STATE OF ARKANSAS  
DEPARTMENT OF POLLUTION CONTROL AND ECOLOGY  
8001 NATIONAL DRIVE, P.O. BOX 9583  
LITTLE ROCK, ARKANSAS 72209

TO : Tony Morris  
FROM : Dick Cassat  
DATE : 20-AUG-1986  
SUBJECT : Jonesboro LF report

SUBJECT : Review of Jonesboro City Landfill Hydrogeologic Report August 1, 1986.

Figure 1. Structure  
 MAP OF THE TOP OF  
 THE CLAIBORNE CLAY.

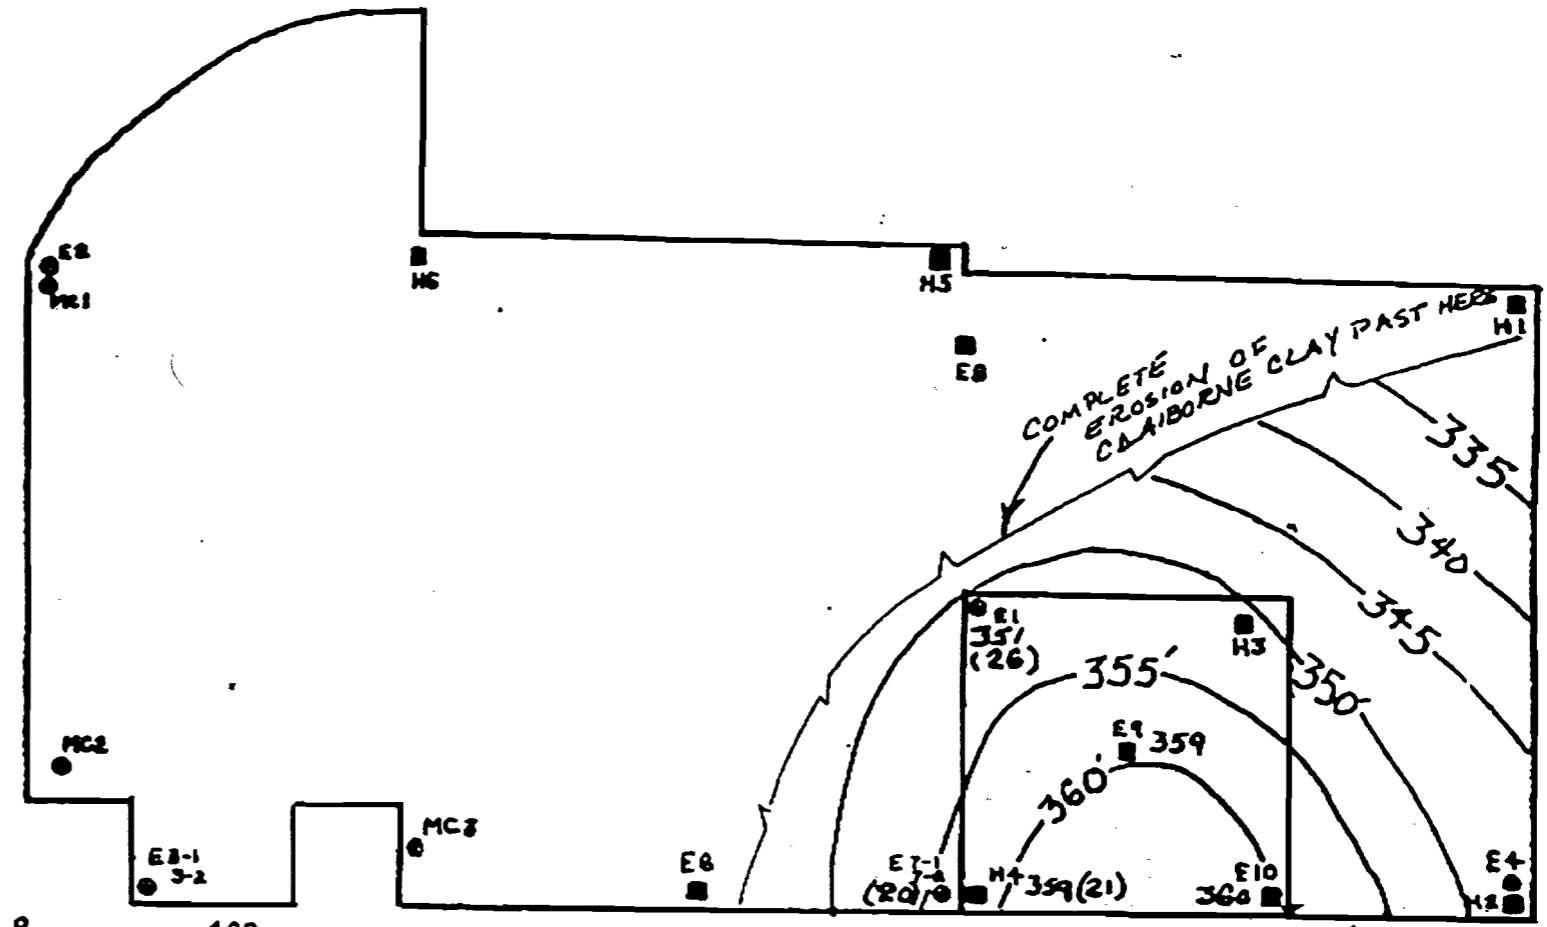
In the interim, please confine landfilling of Class I waste to the Southeast 1/3 of the site as delineated on figure 1 of the submitted preliminary report which is shown as an area that is underlain by a 20' thick clay strata.

- I. Will you send me a copy of Mr. Dick Cassatt's memo of 8-20-86?
- II. You approved the continuation of depositing of Class I type waste in the southeast 1/3 of the site; therefore, am I correct in assuming that the City of Jonesboro can continue to use the area as indicated on the attached drawing?
- III. Will you send me a copy of the additional requirements, as determined by the Solid Waste Division of your Department, to be followed by the City for continued use of the Landfill as a Class IV facility?
- IV. Several places in Mark Witherspoon's memo he implies that he has some reservations with the monitoring wells that Enviromed installed. Therefore, since I am going to be working on the remedial action plan that will include taking water samples from the monitoring wells, can you tell me if these wells are of any value to the City of Jonesboro or not?

1. A copy of Mr. Dick Cassat's memorandum is attached.
2. As indicated in item Number 1 of the September 8, 1986, letter from Dr. Garnett to Mayor Stallings, "...Class I type wastes can continue to be deposited in the southeast 1/3 of the site as previously discussed and within design final contours." The previous discussion of this area is specifically outlined in Dr. Garnett's June 6, 1986, letter to Mayor Stallings as "...the Southeast 1/3 of the site as delineated on Figure 1 of the submitted preliminary report which is shown as an area that is underlain by a 20' thick clay strata." The area you indicated on your map is not the same area as previously discussed. I have enclosed Figure 1 of the preliminary Enviromed report for your convenience.
